UNITED STATES
NUCLEAR REGULATORY COMMISSION

APPLICANT: Westinghouse Electric Corporation
PROJECT: AP600
SUBJECT: SUMMARY OF MEETING TO DISCUSS AP600 REACTOR SYSTEM TESTING ISSUES

RESULTS OF W-EC REVIEW OF PRHR DATA REDUCTION CODE:

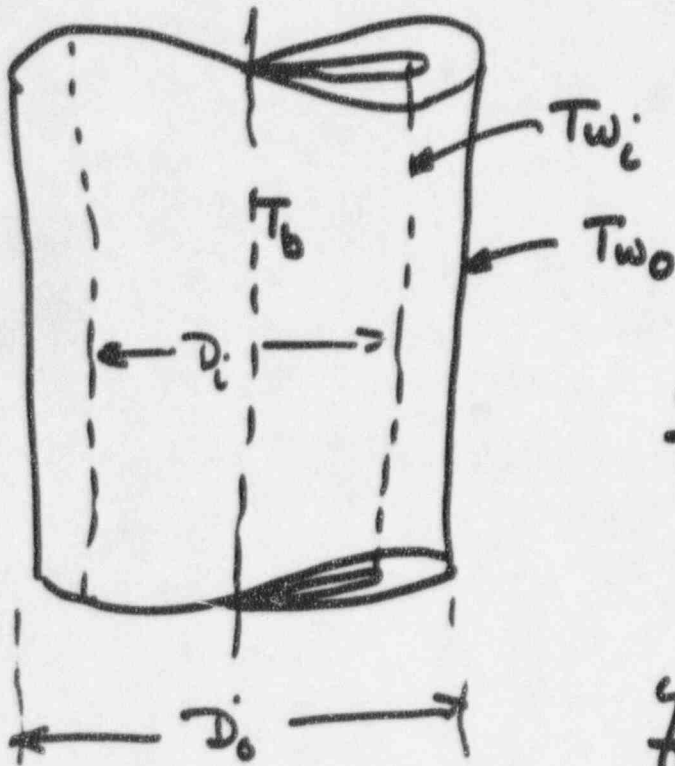
- **DENSITY RATIO IMPLEMENTED IN CODE IS CORRECT SINCE REFERENCE FLOW, Q0, IS REFERENCED TO BASE CONDITIONS**

- **THE DENSITY RELATIONSHIP IDENTIFIED BY INEL IS CORRECT IF REFERENCE FLOW, Q0, IS BASED ON FLOW AT FLOWING CONDITIONS**

- **SINCE VOLUME RATE OF FLOW CALCULATED BY PRHR CODE WAS ASSUMED TO BE AT FLOWING CONDITIONS BUT IS ACTUALLY AT BASE CONDITIONS, CALCULATED VOLUME RATE OF FLOW SHOULD BE MULTIPLIED BY DENSITY AT BASE CONDITIONS TO CONVERT TO MASS RATE OF FLOW**
